Project: IEEE P802.15 Working Group for Wireless Personal Area Networks (WPANs)

Submission Title: [Harmonization of The 15.4g Mandatory Data Rate Proposal]Date Submitted: [17 March, 2010]Source: [Khanh Tuan Le]Company [Texas Instruments][]Company []Address[Gaustadalleen 21, 0349 Oslo, Norway]Voice: [+47 22958535], E-Mail:[k.t.le@ti.com]

Abstract: [Proposal to use 2-GFSK BT=0.5 for 15.4g 50 kbps mandatory data rate. Background and elaboration.]

Harmonization of The 15.4g Mandatory Data Rate Proposal

GFSK Has The Best Spectrum Efficiency

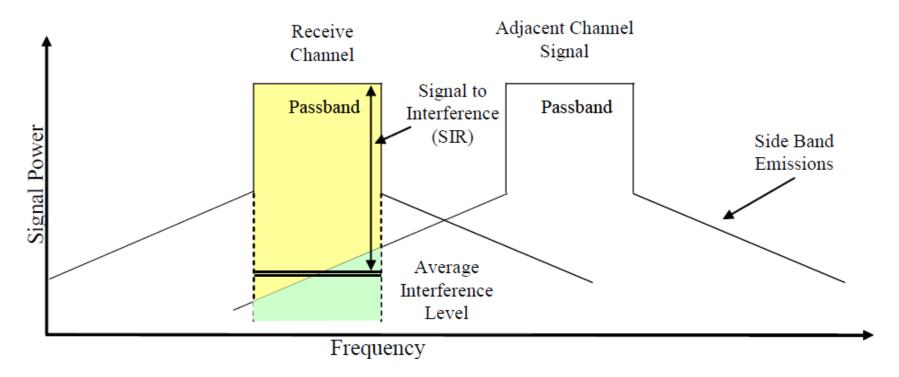
- GFSK has significantly less (>30 dB better) power leakage into neighboring channels than FSK.
- 99% occupied bandwidth: GFSK 25% more compact than FSK.
- ✓ GFSK is inherently more spectrally efficient than FSK.
- ✓ GFSK is better than FSK in terms of co-existence.

Spectrum Utilization and ACI

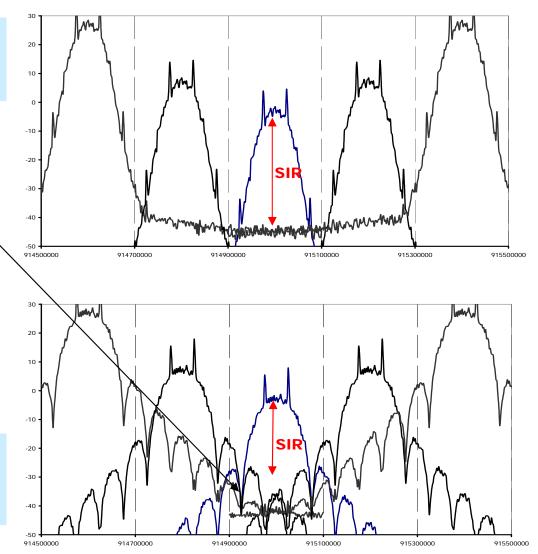
Data Rate: 50 kbps Modulation Index: 1.0 2-GFSK BT=0.5 Channel Spacing: 200 kHz

Unwanted signal power leaked into neighboring channels can result in:

Reduced system performance

More demanding Adjacent Channel Rejection (ACR) requirements, i.e.
 higher complexity and more power
 hungry radios (more signal power and signal processing required for the same SIR)

> Data Rate: 50 kbps Modulation Index: 1.0 2-FSK Channel Spacing: 200 kHz
